V2500-A5 PROPULSION SYSTEMS SERVICE BULLETIN

This document transmits the Initial Issue of Service Bulletin EV2500-73-0172

ENGINE FUEL AND CONTROL – FUEL METERING UNIT – INTRODUCTION OF A WOODWARD GOVERNOR
COMPANY SWITCHABLE FUEL METERING UNIT SUITABLE FOR ALL V2500-A5 APPLICATIONS

Fuel and Control - Fuel Metering Unit (FMU) - Introduction of New Models 8061-636 and 8061-637 and Conversion Instructions

Conversion Procedures
(Sheet 2 of 4)

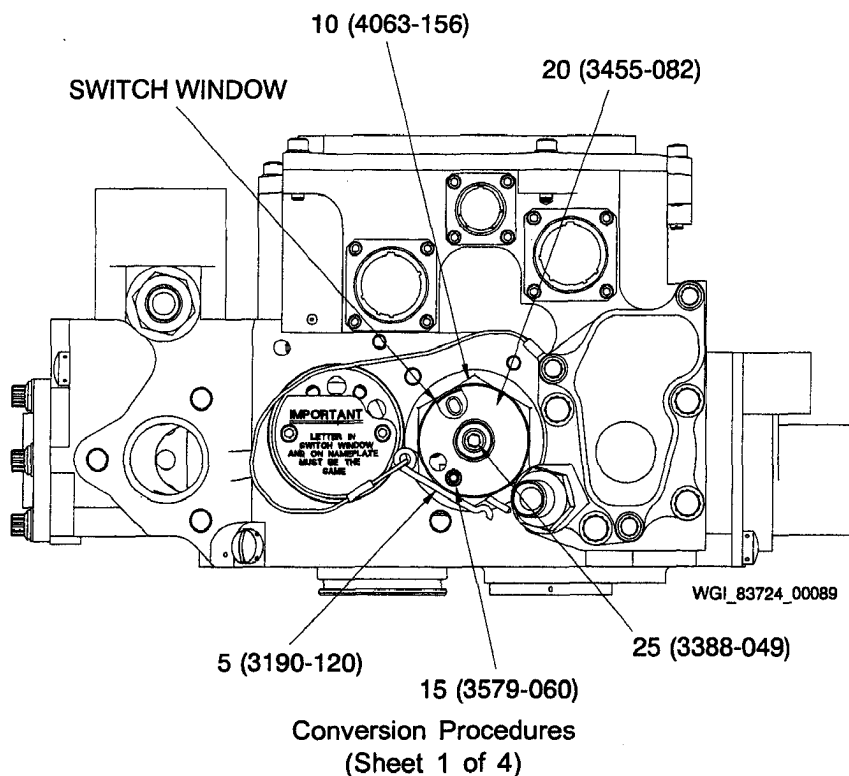
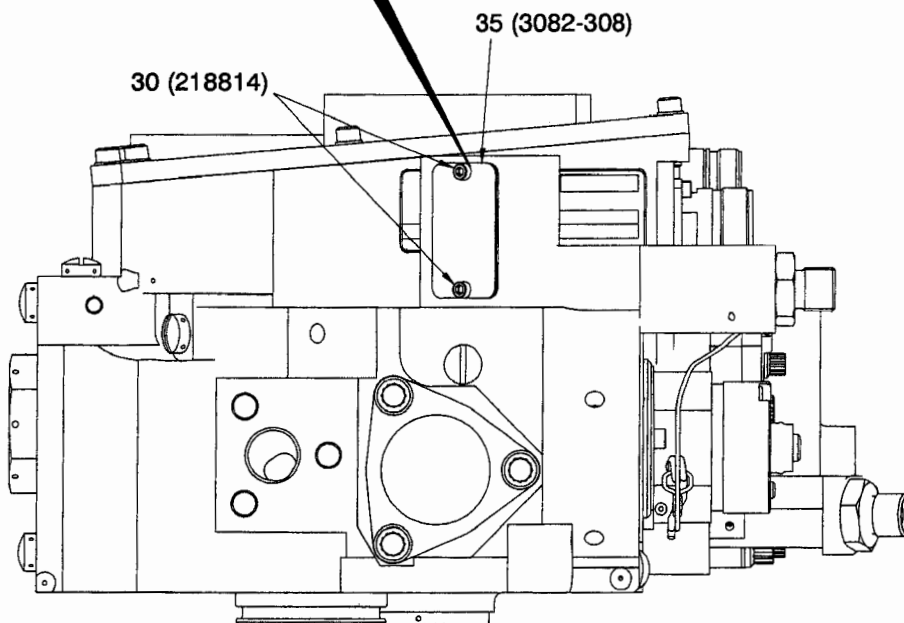
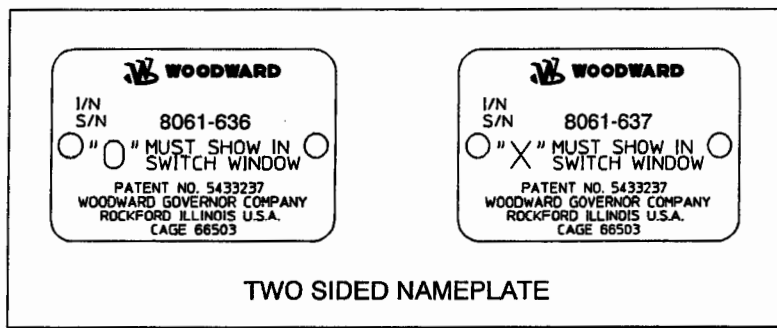
(1) Remove safety wire from plug assembly (10, sheet 1)

(2) Pull out pin (5) from plug assembly (10).

(3) Use hex tool to rotate detent (15) clockwise until there is sufficient clearance between the top of the detent (15) and the cap (20) to allow movement of the cap.

(4) Insert a hex tool into the larger internal hex on shaft (25). Rotate counterclockwise until the letter X is centered in the switch window.

(5) Using a hex tool, rotate detent (15) counterclockwise and torque counterclockwise to 19-22 lb. in. (2,15-2,48 N.m). Ensure that detent (15) prevents cap (20) from rotating.

(6) Install pin (5) into its original location. Be sure pin (5) is secure in the hexagon. Pin (5) should be pushed in until it springs/clicks fully into place.

(7) Remove safety wire from screw (30, sheet 2).

(8) Remove 2 screws (30) from nameplate (35).

- (10) Attach nameplate (35), with side indicating part number 8061-637 visible, with 2 screws (30). If run-on torque is less than 10 oz. in. (0,07 N.m), replace 2 screws (30). If run-on torque still is inadequate, then replace inserts as shown in REPAIR section of CMM 73-28-06. Torque 2 screws (30) to 5.5-6.0 lb. in. (0,62-0,68 N.m).

- (11) Confirm that the letter X shows in the switch window and confirm that the nameplate (35) indicates the part number is 8061-637.
- (12) Install 0.025 inch (0,64 mm) safety wire into eyelet of pin (5, sheet 3). Bend wire back on itself.

Conversion Procedures
(Sheet 3 of 4)

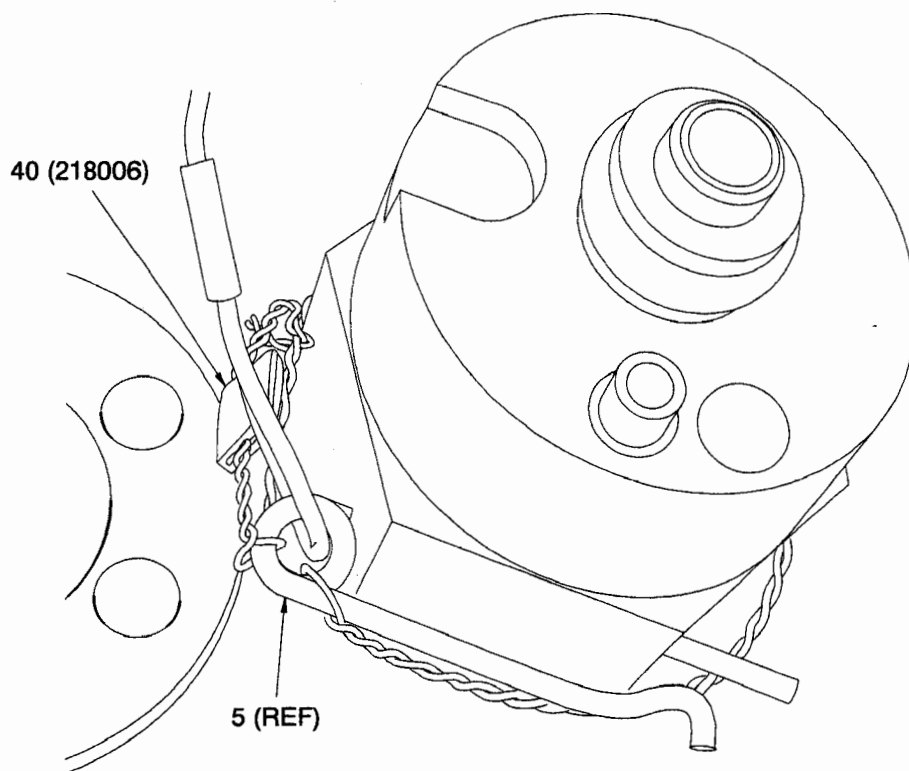
- (13) Twist the 2 wires (using standard double twist method) per SAE AS567, or equivalent. Route the twisted wire under pin (5) and around the plug assembly (10). Be sure that wire is as taut as possible.

- (14) Use one strand of safety wire to loop through the eyelet of pin (5). Twist the wire pair again to be sure that the wire is firmly attached to the eyelet of pin (5).

- (15) Attach one seal (40) per SAE AS567, or equivalent, and apply end twists. Use WT-140418 assembly tool to crimp seal (40) or use method in CMM 73-28-06 ASSEMBLY. Tie down the pigtail of the safety wire to the safety wire underneath.

Conversion Procedures
(Sheet 4 of 4)

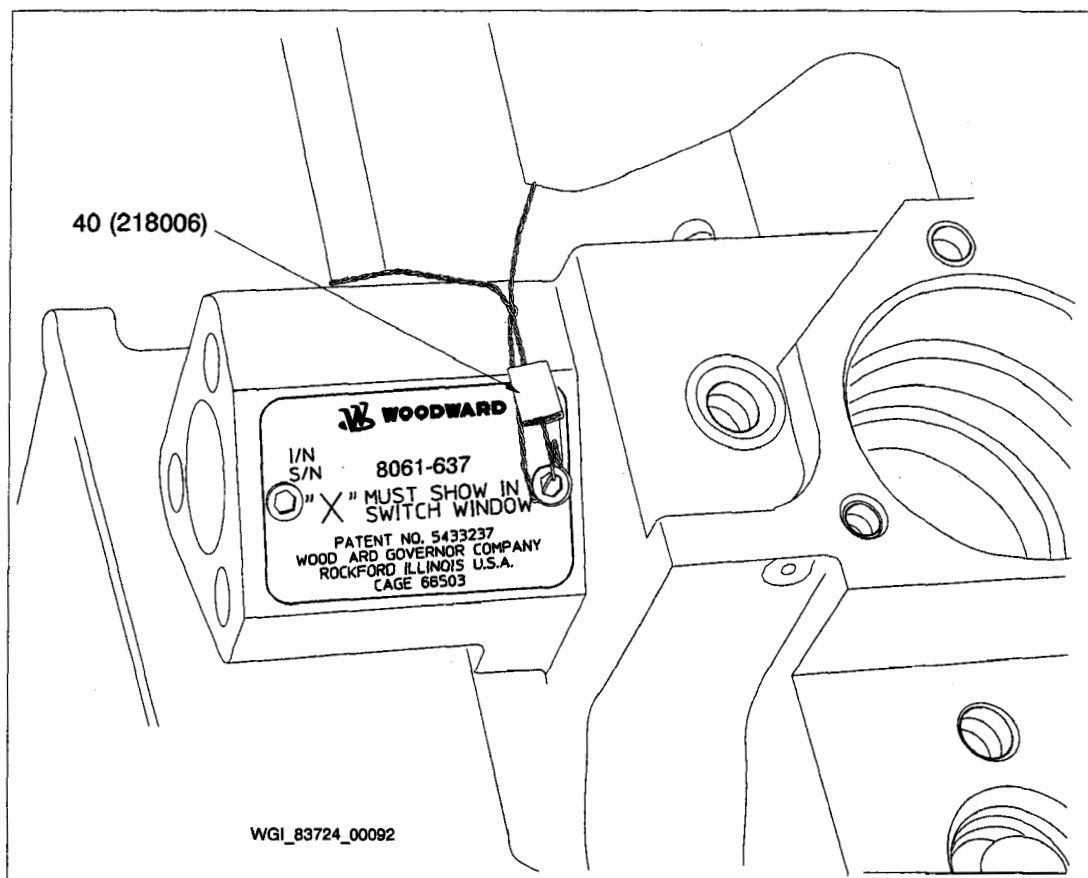
- (16) Install 0.020 inch (0,51 mm) safety wire in screw (30, sheet 4).
- (17) Twist and loop safety wire underneath LP pump inlet boss. Route twisted safety wire back over the top of the LP pump inlet boss.

- (18) Stop twist of the wires at intersection where the two wires meet. Loop the two wire strands around the twisted safety wire.
- (19) Twist the wire, after the loop, such that the two sets of safety wire are attached. Install one seal (40) per SAE AS567. Use WT-140418 assembly tool to crimp seal (40) or use method in CMM 73-28-06 ASSEMBLY.

- (20) Finish wire twists and tie down safety wire to screw (30).
- (21) Do the checks that follow:
 - Check nameplate to make sure part number 8061-637 is visible.
